IN THE DRAWINGS

REMARKS/ARGUMENTS

FIG. 1

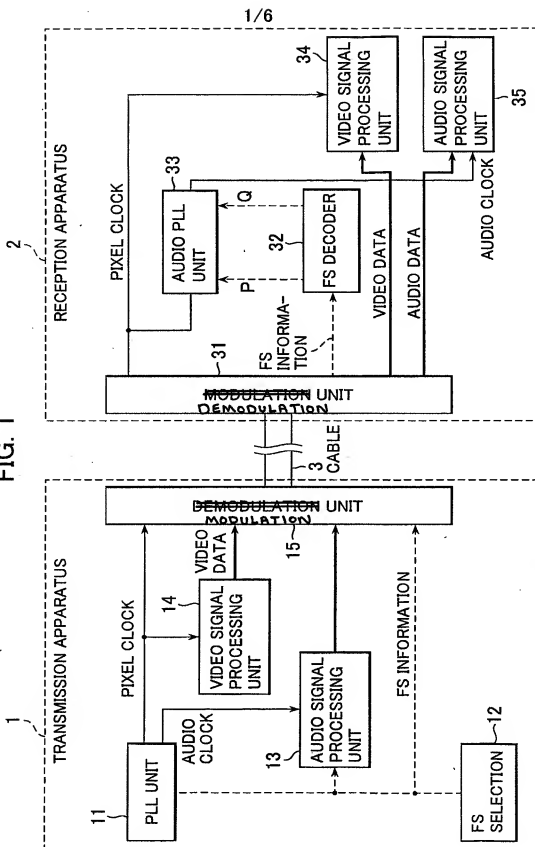
In Fig. 1, inadvertent typographical errors corresponding to elements 15 and 31 have been amended; and

Fig. 1 and Fig. 2 have been amended to address minor typographical errors. These corrections are fully supported by Applicant's disclosure. In Fig. 1, the text "DEMODULATION UNIT" associated with element (15) of the transmission apparatus (1) has been replaced by "MODULATION UNIT." Conversely, the text "MODULATION UNIT" associated with element (31) of the reception apparatus (2) has been replaced by "DEMODULATION UNIT." These amendment are supported by paragraphs [0023]-[0024] of Applicant's disclosure. In Fig. 2, the text "DIVISION RATIO Q" associated with the broken line connecting the Fs decoder (32) to the variable divider (55) has been replaced by "DIVISION RATIO P." This amendment is supported by paragraph [0042] of Applicant's disclosure.
